Access Report

**Lower Hunter Medical  
Centre**

271 New England Highway  
RUTHERFORD NSW

Ref: LP\_22178

Figure 2 | Overall Site Plan

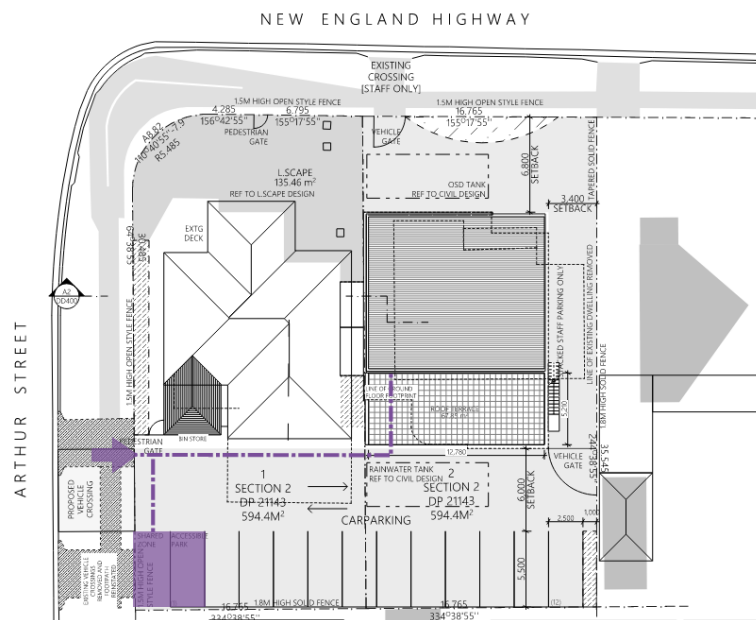
An accessible path of travel is provided to the building entrance from the allotment boundary along Arthur Street via the driveway area.

An accessible path of travel is provided from the carparking area to the building entrance.

An accessible car parking space with associated shared area is provided within the general carparking area.
